Product Change Notice (PCN)

PCN Number: **PCN-0456164R**

Product(s) Affected: **PJ-036D**

PREVIOUS CUI DEVICES DETAIL / IMAGE	NEW CUI DEVICES DETAIL / IMAGE

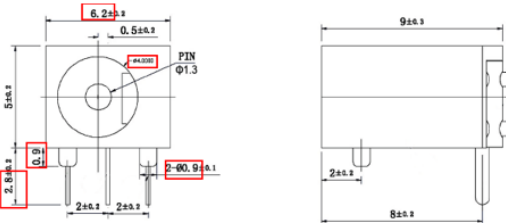
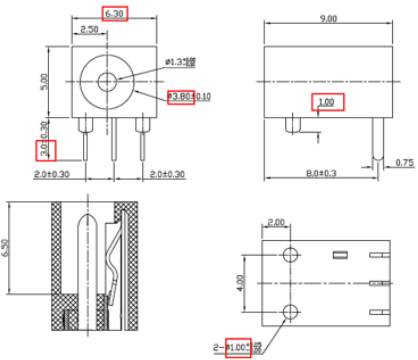
Description of Change: **New Factory Location. Product re-engineered for improved manufacturability and production yield. See image below for reference and check CUI Devices website for updated drawing. Cosmetic differences may be visible and not affect the form fit and function of the product.**

PREVIOUS CUI DEVICE'S DETAIL / IMAGE			NEW CUI DEVICE'S DETAIL / IMAGE		
DESCRIPTION	MATERIAL	PLATING/COLOR	DESCRIPTION	MATERIAL	PLATING/COLOR
center pin	brass	silver	center pin	brass	silver
terminal 1	brass t=0.25	silver	terminal 1	brass t=0.25	silver
terminal 2	brass t=0.25	silver	terminal 2	SUS301 t=0.25	silver
terminal 3	brass t=0.25	silver	terminal 3	brass t=0.25	silver
housing	PBT (UL94V-0)	black	housing	PPA (UL94V-0)	black

MATING PLUG
Jack Insertion Depth: 6.4 mm

MATING PLUG
Jack Insertion Depth: 6.5 mm
